Application for Non-Material Amendment (S96a)
Land North of Sefter Road and 80 Rose Green Road, Pagham

We are writing to submit an application for a Non-Material Amendment (NMA) to reserved matters ref. P/49/21/RES at the site Land North of Sefter Road and 80 Rose Green Road, Pagham.

Table 2: Response to NMA 6 Comments

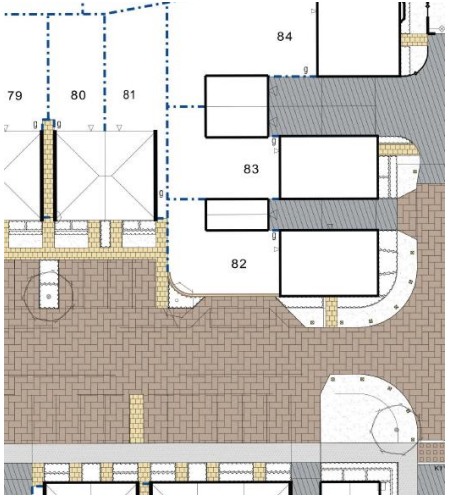
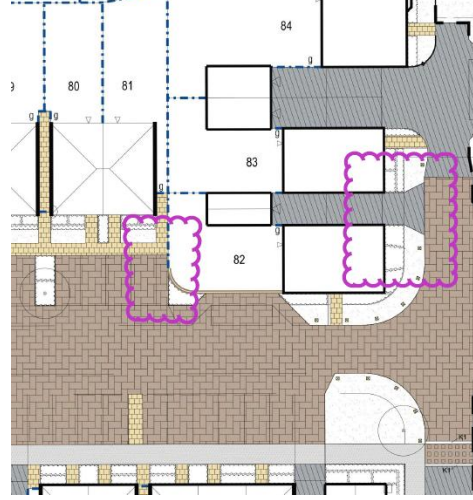
Footpath materiality is shown as vehicular bituminous surface on the footpath between plots 229, 230 and 225. This is shown to be footpath / cycleway bituminous surface on CB_84_139_101 and other site plans.

The Hard Landscape Proposals Sheet 3 (ref. 2038_136 rev G) has been updated to provide separate material footpath around to car parking spaces at Plots 225 and 229.

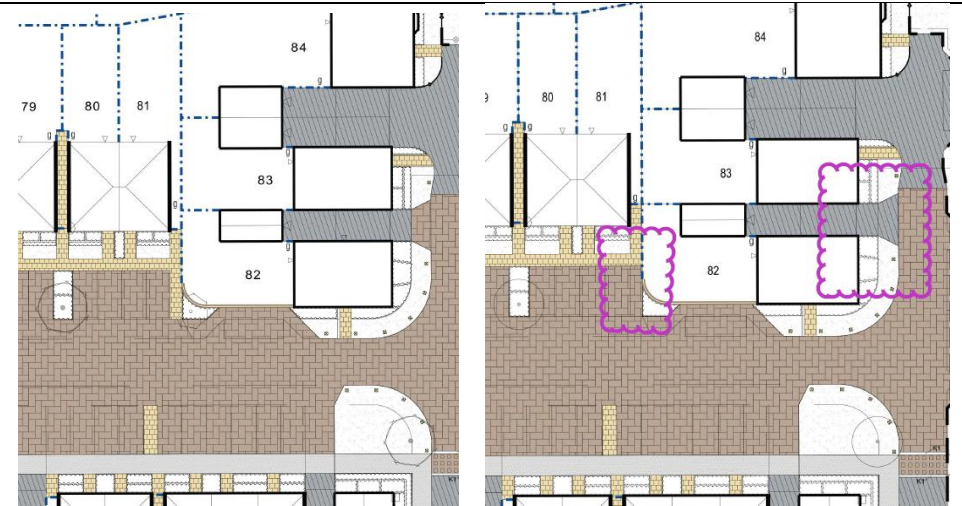
Paving slab shown to south of Plot 81, but is block paving on CB_84_139_101.	The Hard Landscape Proposals Sheet 3 (ref. 2038_136 rev G) has been updated to remove the slab by Plot 81 . Sheet 3 rev E  Sheet 3 rev G 
	Drop kerb access to plot 82 shown as block paving, but should be bituminous as per CB_84_139_101	The Hard Landscape Proposals Sheet 3 (ref. 2038_136 rev G) has been updated to add tarmac at the dropped kerb at Plot 82 . Sheet 3 rev E Sheet 3 rev G

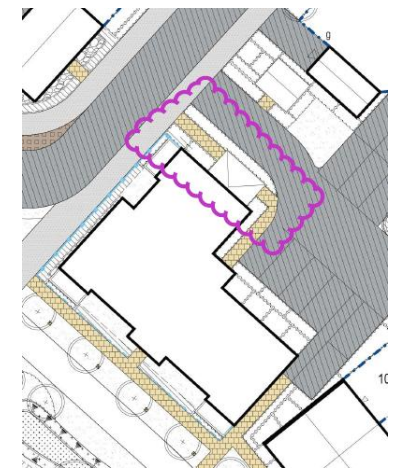
Bituminous hatching missing for parking spaces in parking area to north of Block B. This is shown as soft landscaping.

The Hard Landscape Proposals Sheet 3 (ref. 2038_136 rev G) has been updated to add slab paving by Block B

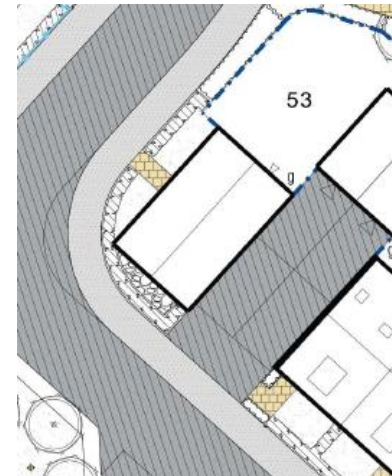
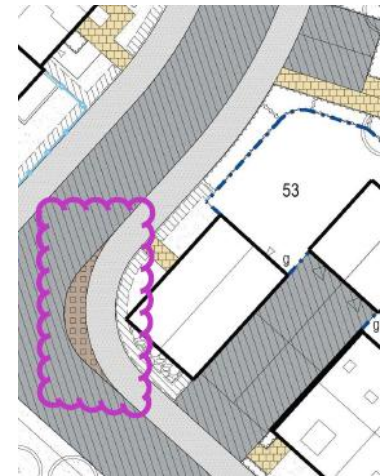
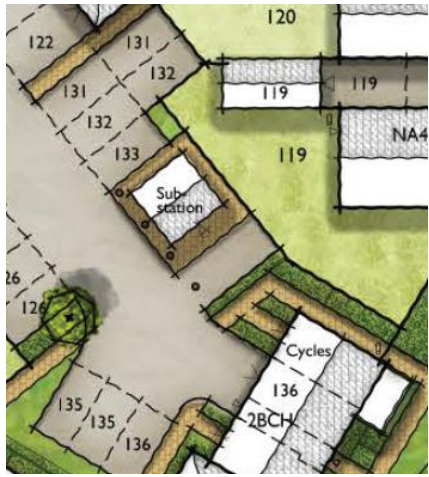
Hatching is incorrect on corner to front of Plot 53. This is shown as vehicular bituminous surface, however the adjacent corner outside Plot 58 is denoted as concrete sett paving.

CB_84_139_101 shows these corners to both be bituminous surfacing to match the footpath.

The Hard Landscape Proposals Sheet 3 (ref. 2038_136 rev G) has been updated to include concrete set paving by Plot 58.

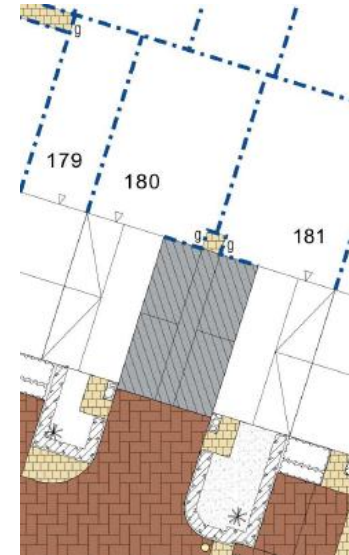
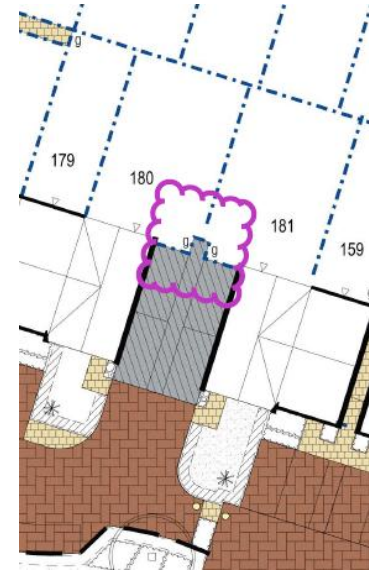
A very small area of paving slab is shown to the north of parking spaces for blocks 180 and 181. It is queried whether this should be paving slab or bituminous, as CB_84_139_101 indicates this is bituminous.

The Hard Landscape Proposals Sheet 4 (ref. 2038_137 rev G) has been updated to provide tarmac by Plots 180 and 181.

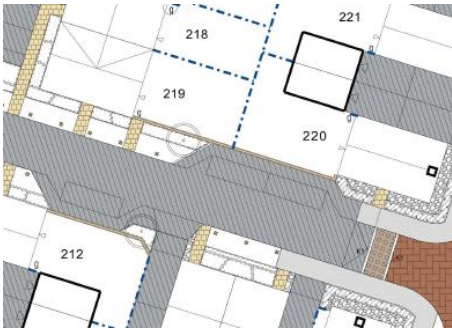
The drop kerb to front of parking for Plot 220 and 221 is shown as bituminous surface, but is shown to be block paving on CB_84_139_101 and other site plans.

The Planning Layout has been updated to tarmac (bituminous surface) at the drop kerbs by Plots 220 and 221.
